**RE: Blake's Lotaburger #64
1801 Juan Tabo Blvd. NE
Grading and Drainage Plan
Engineer's Stamp Date: No Stamp Date
Hydrology File: H21D012**

Based upon the information provided in your submittal received 04/25/2019, the Grading & Drainage Plan **is not** approved for Building. The following comments need to be addressed for approval of the above referenced project:

Sheet Name
GRADING AND DRAINAGE PLAN

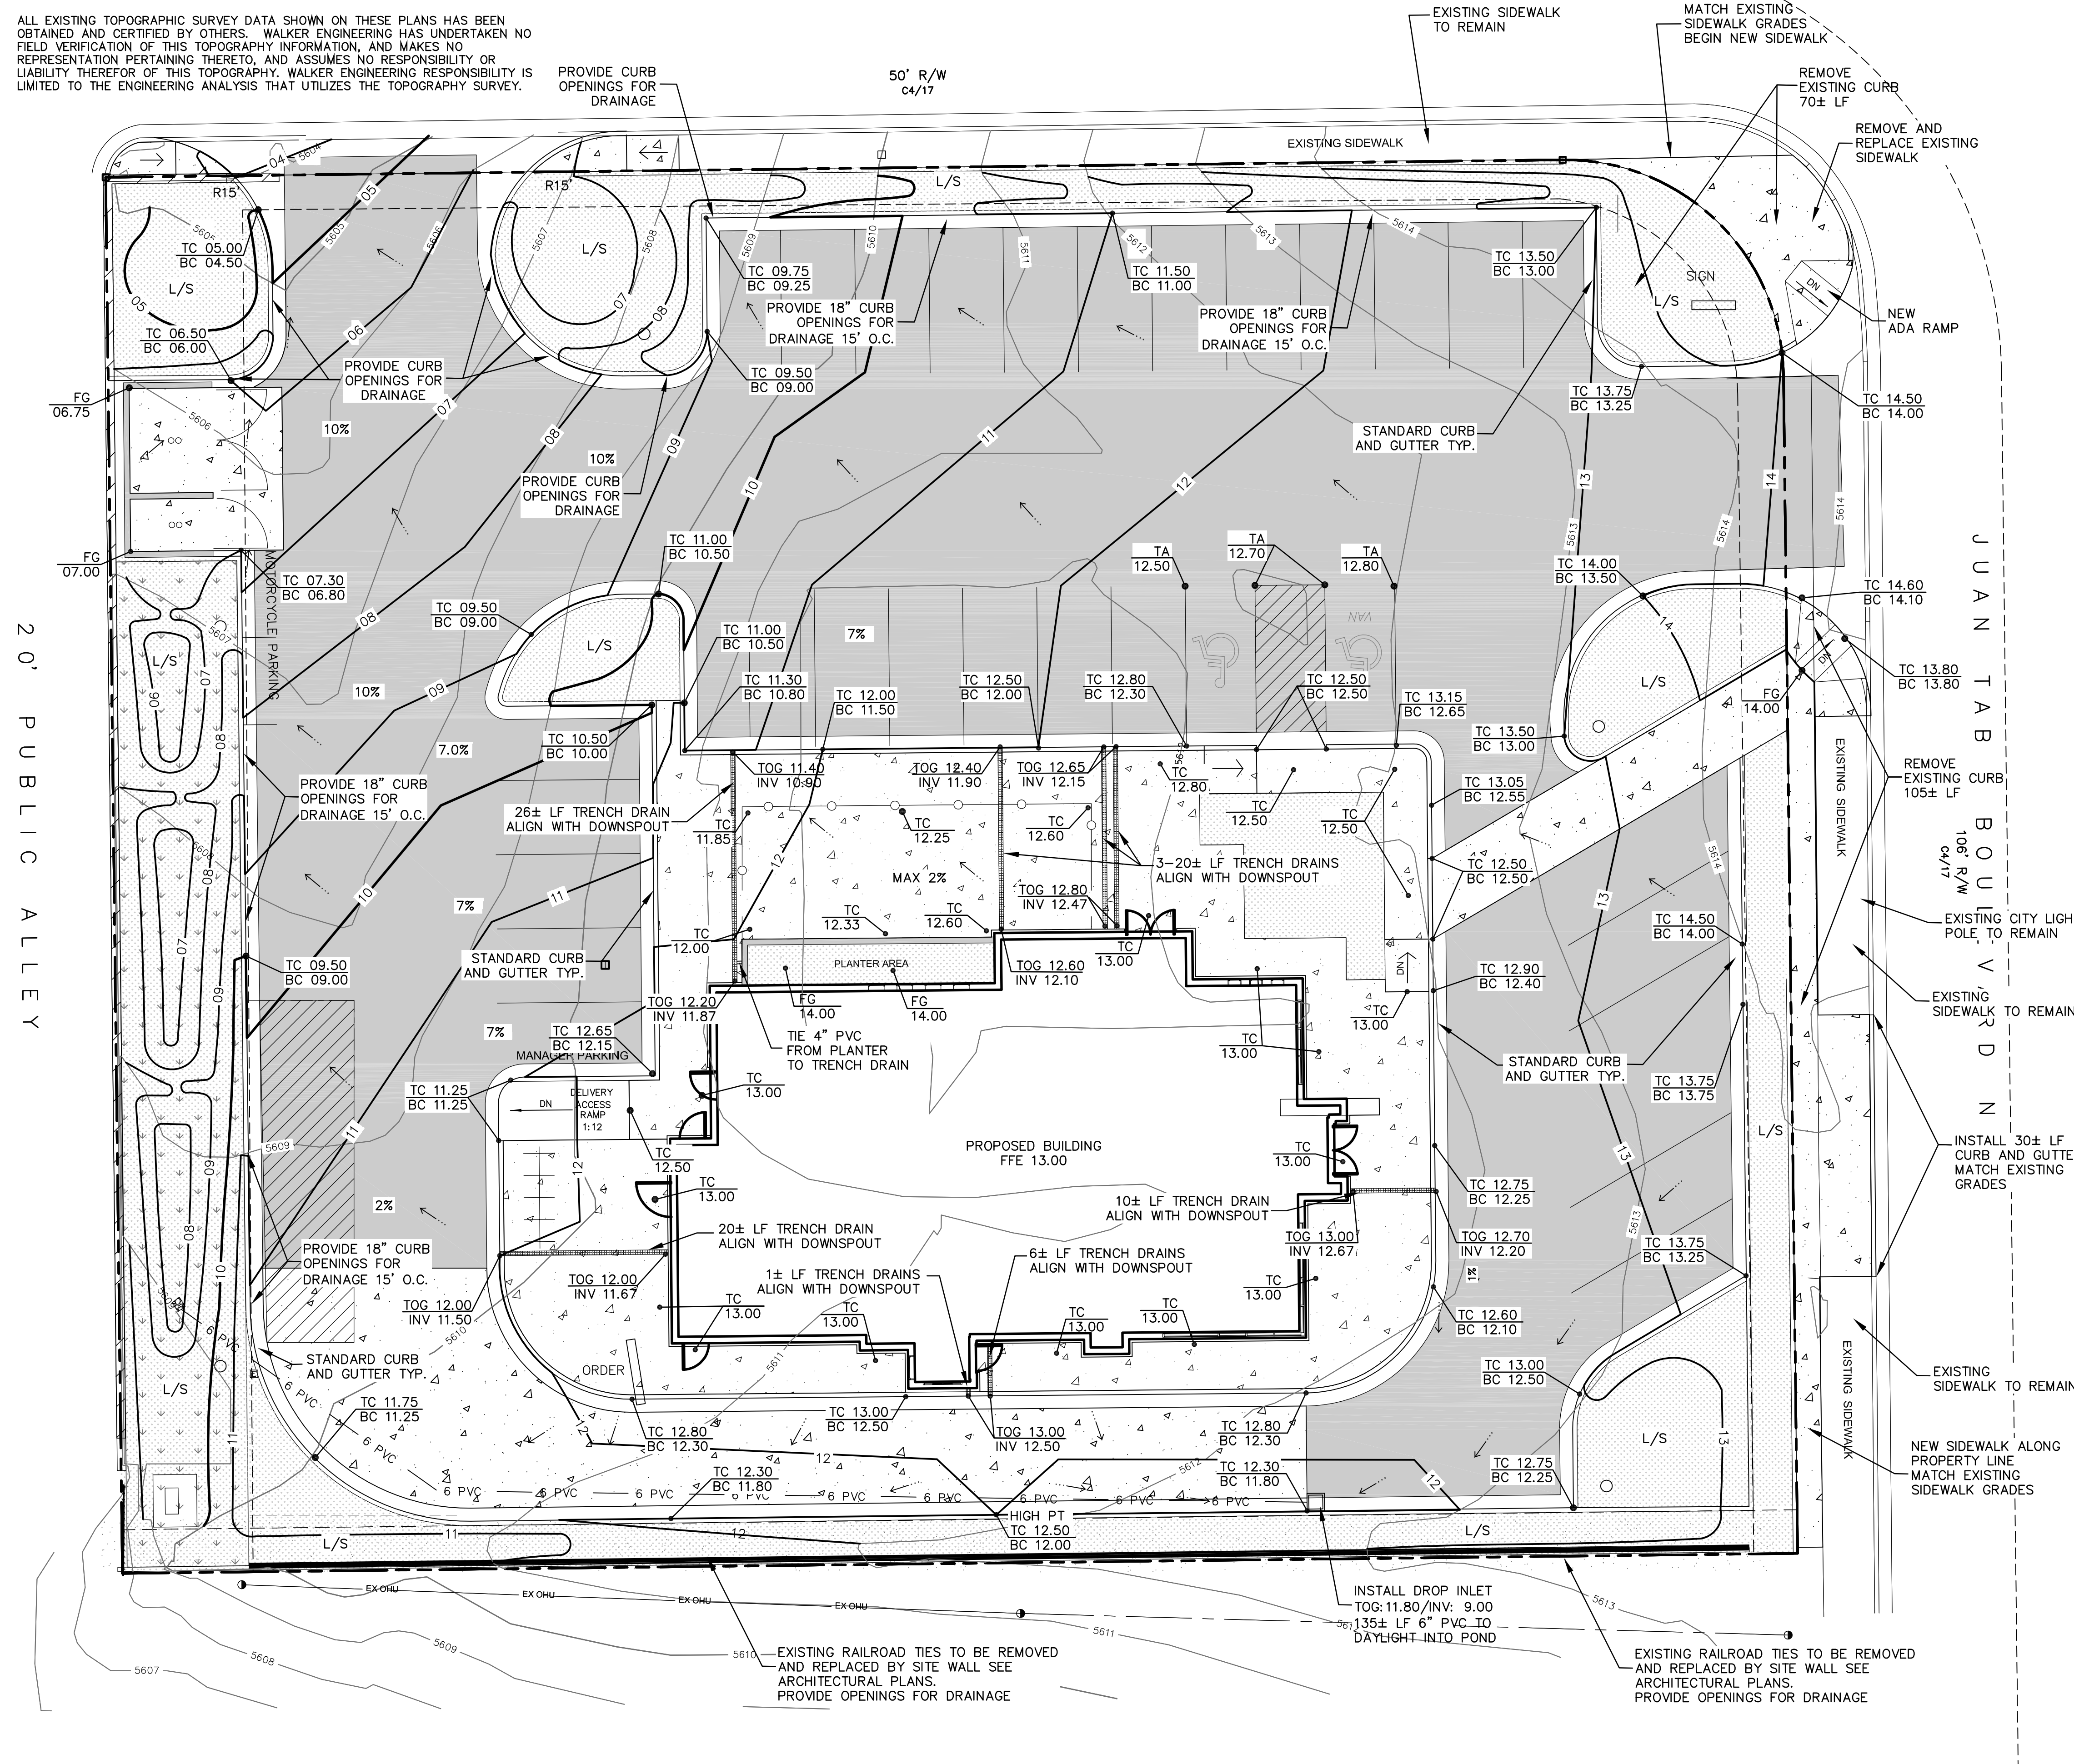
1. Please provide an engineer's stamp date.
2. Please provide all missing information from the Grading Plan Checklist. (c, d, e, & f) Per the DPM Chapter 22 Section 7 - Grading Plan Checklist, the following must be on the Grading Plan.

- a. Please provide an engineer's stamp with a signature and date.
 - b. Please use 1" = 20' for the scale.
 - c. Please provide a Vicinity Map.
 - d. Please provide the Benchmark information (location, description and elevation) for the survey contour information provided.

- e. Please provide the FIRM Map and flood plain note with effective date.
 - f. Please provide a legal Description of the property.
3. Please use the procedure for 40 acre and smaller basins as outlined in Chapter 22, Part A of the Development Process Manual (DPM). Please provide both the existing conditions and proposed conditions for the 100 year-6 hour storm event. See Attached pdf (this is a draft of the DPM update). This site is in Precipitation Zone 4.

4. The storm water quality (SWQ) volume for this site is required in order to manage the storm water runoff. Since this is a redevelopment site, the storm water quality volume is calculated based on the 0.48 inch storm. To calculate the required storm water quality volume to be captured, multiply the impervious area by 0.28 inches for the 80th

percentile storm. This required storm water quality volume can be captured within the depressed areas of the landscaping. Please also state the total provided storm water quality volume for the site.

5. Please label each storm water quality pond with the provided SWQ volume.
6. Please provide the weir calculations for the curb cuts per the DPM. A coefficient of 2.7 is typically used for the equation $(6.60) Q = CLH^{2/3}$.
